Re: Comments on PRB Expansion DEIS
Presented to the Surface Transportation Board
Sections: 4.4.5.2 Geologic Hazards, 4.4.5.3 Soil Impacts, 4.4.12 Safety

In accordance with the authorization of the Midstates Coalition for Progress, McGhie & Betts Environmental Services, Inc. (MBESI) has completed an assessment of the proposed DM&E Alternatives B and C for rail line constructions between Wall, South Dakota, and Smithwick, South Dakota. MBESI is an environmental consulting company located in Rochester, Minnesota with a staff of three geologists and a soil scientist with over 70 years of combined experience in evaluating environmental and geological hazards.

Figure 2: Block diagrams showing different types of heave features associated with heaving bedrock (modified from Noe and Dodson, 1995).

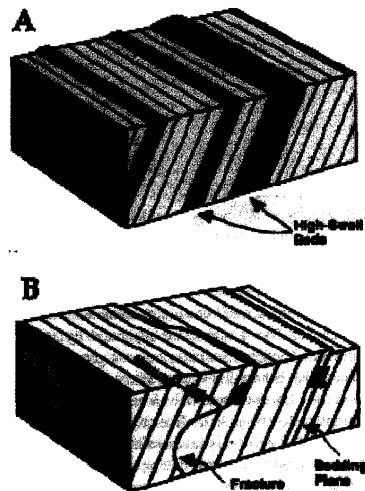
As seen in the heaving bedrock illustrated from Colorado in the above figure, the uplift is not uniform in areas of tilted strata. This situation exists in the Cheyenne River Valley where the Pierre Shale is tilted away from the Buffalo Gap Monocline south of Rapid City. In areas like the Cheyenne River Valley where the Pierre Shale Formation is tilted, heave features are usually dramatic and pose severe engineering limitations to any construction. The following figure illustrates the problem.

As stated in section 4.4.5.2 of the DEIS, "In South Dakota and Wyoming, portions of all alternatives cross the Pierre Shale and Fort Union Formations" however, the DEIS does not note the fact that the dipping formations are not horizontal and the DEIS does not recognize the risk. Heaving, shrinking and swelling of a rail line, regardless of the extent, poses a threat to rail bed stability and operational safety. In our professional opinion it will be difficult or impossible to design and construct a new rail bed grade for Alternative B or C that will prevent the hazards associated with heaving shale of the Pierre Shale Formation.

Figure 2: The above figure depicts the first encountered bedrock throughout the state of South Dakota. The area labeled as Upper Cretaceous (shale, chalk) generally refers to the Pierre shale formation. (South Dakota Geological Survey, 2001)

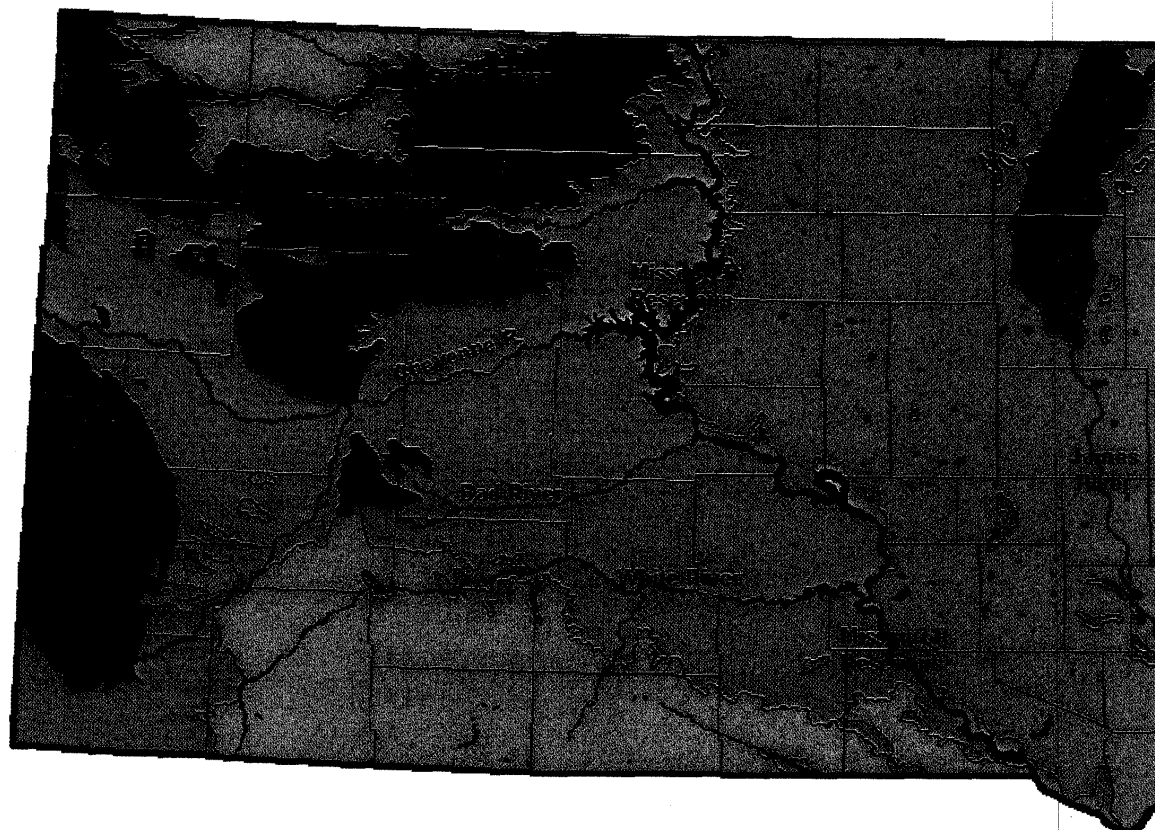
The above maps and tables show a direct correlation between railroad accidents and the occurrence of the Pierre Shale as the first encountered bedrock underlying the rail bed grade in South Dakota. Our analysis indicates that a majority of the railroad accidents that have occurred in the past 15 years have been on tracks underlain by the Pierre Shale indicating that unstable track conditions contributing to rail accidents is a clear and present danger for Alternatives B and C.

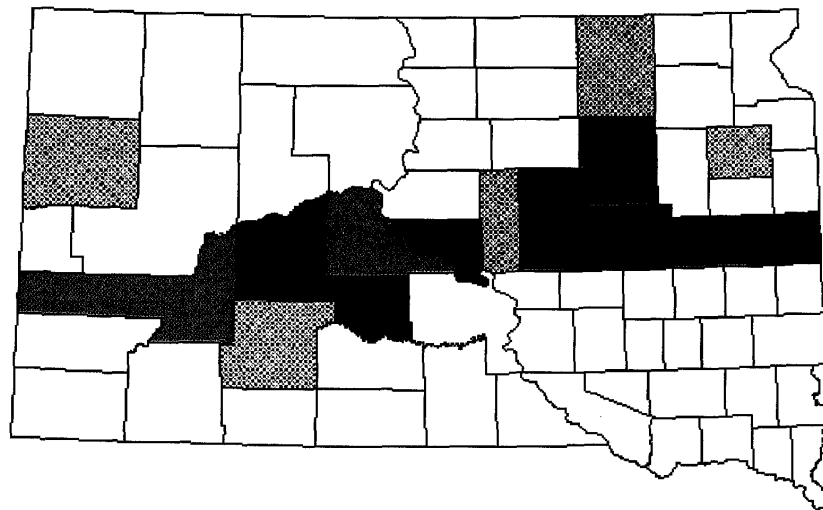
Figure 3: The above map and table shows all rail accidents, excluding highway rail accidents that have occurred on DM&E railroad in South Dakota over the past 15 years. Using the bedrock geology map (Figure 2) you can see that the majority of railroad accidents in the past 15 years have occurred on rail line that is underlain by the Pierre shale formation. Once the rail line crosses the Missouri River and is no longer directly underlain by the Pierre shale the rail accidents decrease. (Federal Railroad Administration, Office of Safety Analysis, 2001)

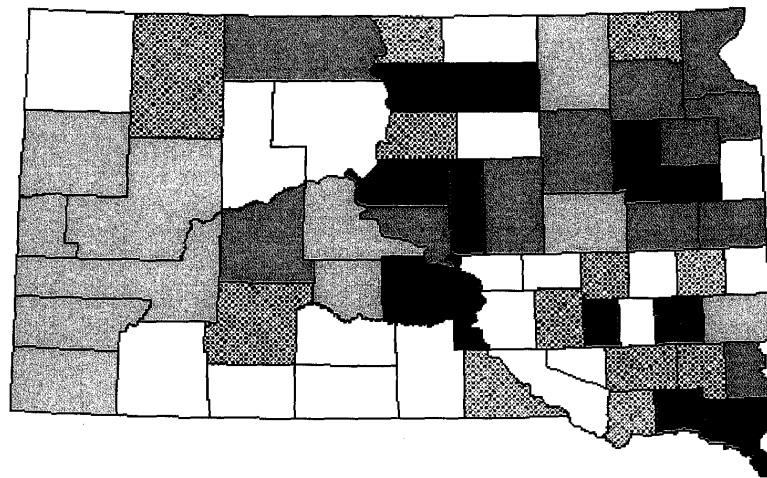
Figure 4: The above map and table shows all rail accidents, excluding highway rail accidents that have occurred on all railroads in South Dakota over the past 15 years. Using the bedrock geology map (figure 2) you can see that the majority of railroad accidents in the past 15 years have occurred on rail line that is underlain by the Pierre Shale formation. Once the rail line crosses the Missouri River and is no longer directly underlain by the Pierre Shale the rail accidents decrease. (Federal Railroad Administration, Office of Safety Analysis, 2001)

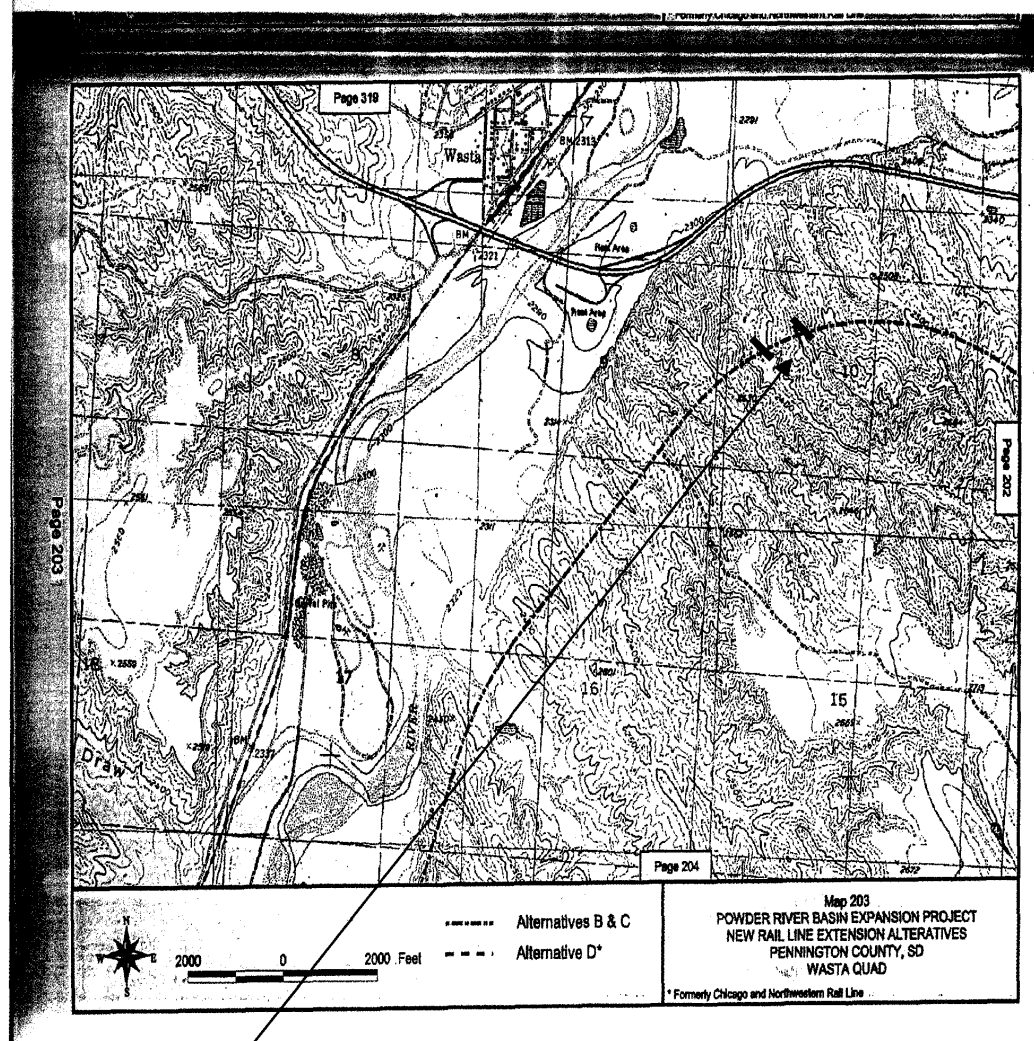
Construction of either Alternative B or C in the Cheyenne River valley will require major grading including massive cut and fill sections in the geologically unstable Pierre Shale. As stated in the DEIS, section 4.4.5.2, Alternative B (Proposed Action), "The potential for slumps and landslides would be high where this alternative would cross steep slopes or where cutting or loading of slopes or unusually high precipitation events may cause landslides. In South Dakota, approximately 40.8 miles of the Pierre shale formation would be crossed." In order to maintain the proposed engineering constraints of 1-degree maximum curvature and 1 percent maximum grade, cutting and loading will need to be done extensively along the already unstable undisturbed banks of the Cheyenne River valley. Figure 5 illustrates the difficult and imprudent option presented in alternative B and C.

Figure 5: Within this 1000-foot section of proposed rail line in section 10 we find a maximum ground level elevation of 2500' and a minimum ground level elevation of 2360'. With a relief of 140' over 1000' a valley or ravine with a 14% slope must be cut and filled to construct the 1% maximum grade. The Pierre Shale is not suitable material for the fill section and must be over-excavated and re-filled in the cut section making Alternatives B & C unfeasible.
